Re: In the Matter of Florida Power and Light  
Company (St. Lucie Plant, Unit No. 1)  
Docket No. 50-335-OLA

SUBJECT: ST. LUCIE UNIT 2 - ISSUANCE OF AMENDMENT RE: TRANSFER OF SPENT  
FUEL (TAC NOS. 61938 AND 61939)

SAFETY EVALUATION BY THE OFFICE OF NUCLEAR REACTOR REGULATION  
RELATING TO THE TRANSFER OF UNIT NO. 1 SPENT FUEL  
BETWEEN UNIT NO. 1 AND UNIT NO. 2 OF THE ST. LUCIE PLANT  
RELATING TO AMENDMENT NO. 30  
TO FACILITY OPERATING LICENSE NO. NPF-16  
FLORIDA POWER & LIGHT COMPANY, ET AL.  
ST. LUCIE PLANT, UNIT NOS. 1 AND 2  
DOCKET NOS. 50-335 AND 50-389

Figure 2-5. Spent Fuel Cask Transporter Path Between Units 1 and 2

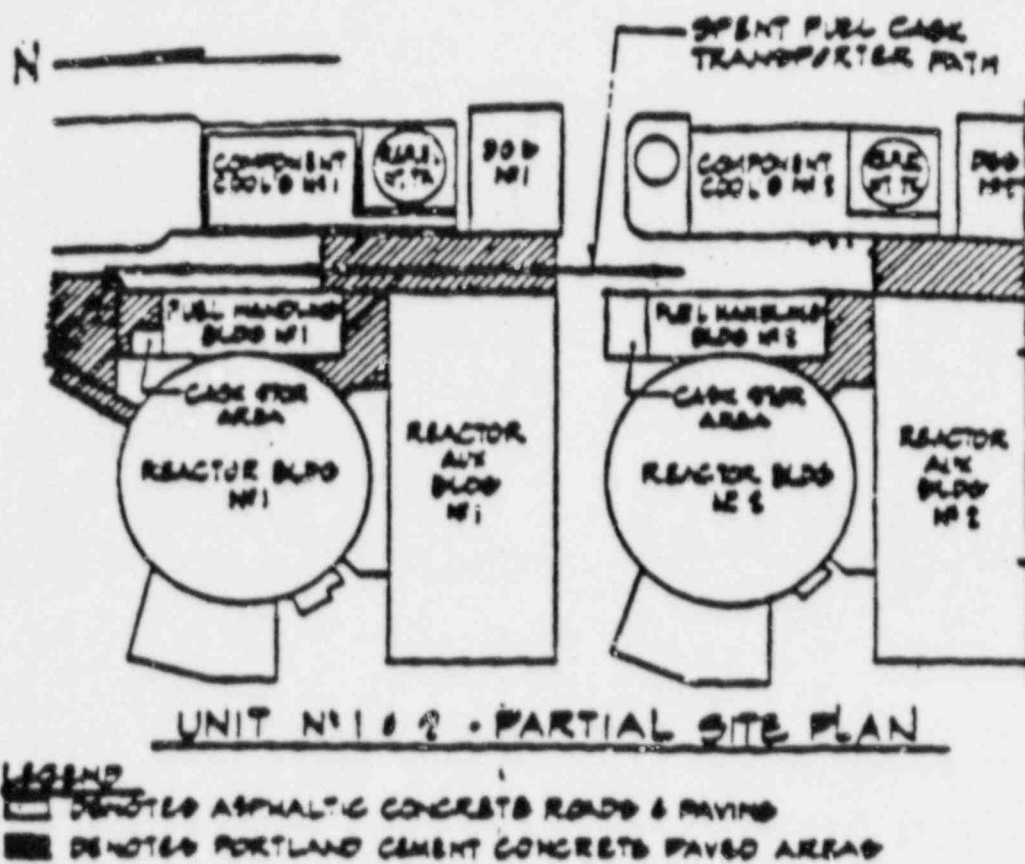
The load path for transporting the shipping cask between the Unit 1 and Unit 2 fuel handling buildings is shown in Figure 2-5. The Licensee stated [1] that this load path has been evaluated and has been found to provide a safe path for transport of the spent fuel assemblies. For each of the two transporter vehicles considered in the load path evaluation, the maximum wheel loads were found to be acceptable considering the effects on all surfaces, including the roadway, missile protection slabs, and underground facilities (i.e., pipes, electric conduit, manholes, and catch basins).

The Licensee submittal [1] does not provide any structural analysis summary or structural details of the underground facilities that will be crossed over by either of the two transporter vehicles carrying the spent fuel shipping casks. The Licensee has been requested [2] to provide specific structural details and data pertinent to the findings regarding the safe load path evaluation (see Section 2.2 for the evaluation of the Licensee's response [3] to the RAI [2]).

Figure 2-7. NL1-1/2 Shipping Cask Data and Configuration

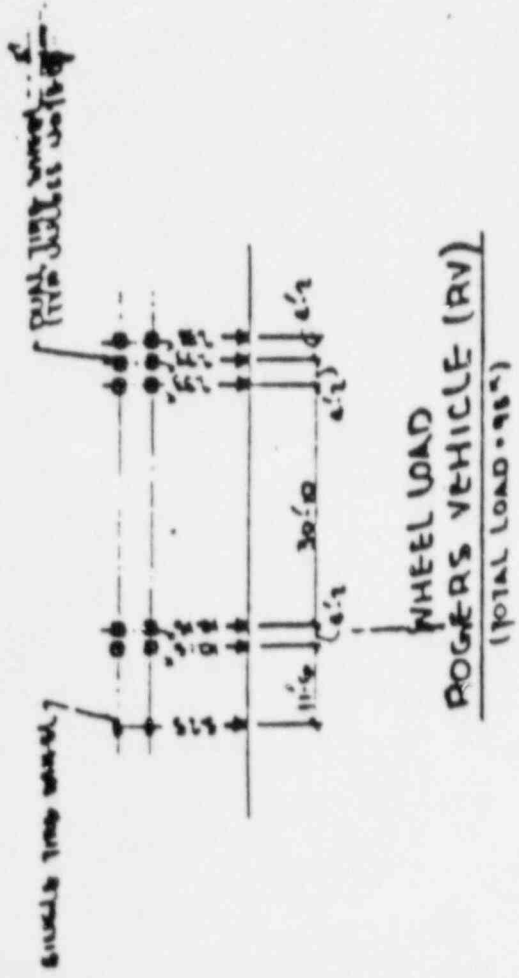
The spent fuel shipping cask that will be used to transfer spent fuel assemblies from Unit 1 to the Unit 2 spent fuel pool would be either the Model NAC-1 or NL1-1/2. These shipping casks have certificates of compliance No. 9183, Rev. 3, dated November 14, 1984, and No. 9010, Rev. 17, dated August 28, 1986, respectively, issued by the NRC. The basic configuration and the corresponding design data of the two cask models (NAC-1 and NL1-1/2) are shown in Figures 2-6 and 2-7, respectively.

For the NAC-1 (Figure 2-6), the cask crane hook is detached from the cask crane lifting yoke bale. The hook is washed down with demineralized water as it is retracted out of the pool. For the NL1-1/2 (Figure 2-7), the cask lifting yoke arms are disconnected from the cask using the arm-mounted hydraulic actuating system. The inner cask cover is removed as the yoke is lifted out of the pool. A spray of demineralized water is again used to wash down the cable system, the crane hook, the lifting yoke, and the inner cask cover.

The Licensee response is adequate.

Figure 2-8. Spent Fuel Transporter Wheel Load

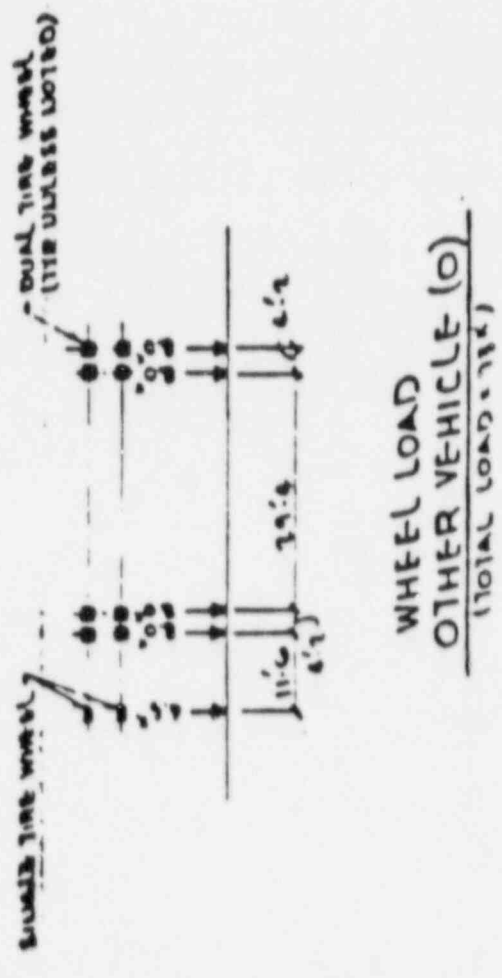
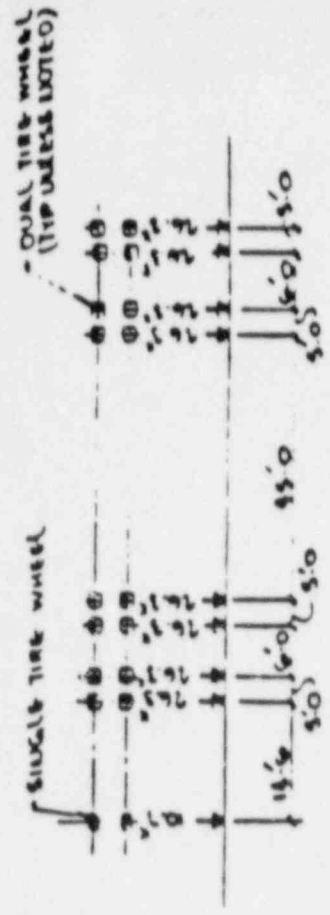
the two cask transporters (RV and O) and the intermodal vehicle as well as wheel information. The information provided in Figure 2-8 is technically sufficient to evaluate structures that would be affected by the loads imposed on the shipping path.

The missile protection slab over the pipe tunnel was designed for the maximum wheel load from the intermodal cask transporter. This load consists of two 23.6-kips concentrated loads spaced 5'0" apart (see Figure 2-8). Each 23.6-kips load represents the maximum load exerted by one dual-tired wheel.

The Rogers vehicle (RV), one of the two possible vehicles to be used for the proposed spent fuel transport between units, consists of a tractor and a drop deck lowboy. The rear wheels of the tractor present a similar case for comparison with the design basis intermodal cask transporter. The maximum wheel load at this location is 10.15 kips per dual-tired wheel; the wheels, and therefore the loads, are spaced 4'2" apart (see Figure 2-8). This case affords a direct comparison with the design basis condition. It is apparent that substantial additional margin is provided in the design to accommodate this load (i.e.,  $10.15 \text{ kips} < 23.6 \text{ kips}$ ).

The other vehicle to be used for spent fuel transport (designated as the "O" vehicle on Figure 2-8) also presents a similar case for comparison with the intermodal cask transporter. The maximum wheel load, either at the rear of the tractor or the rear of the trailer, is 8 kips per dual tire wheel; the

The Licensee's response is adequate.
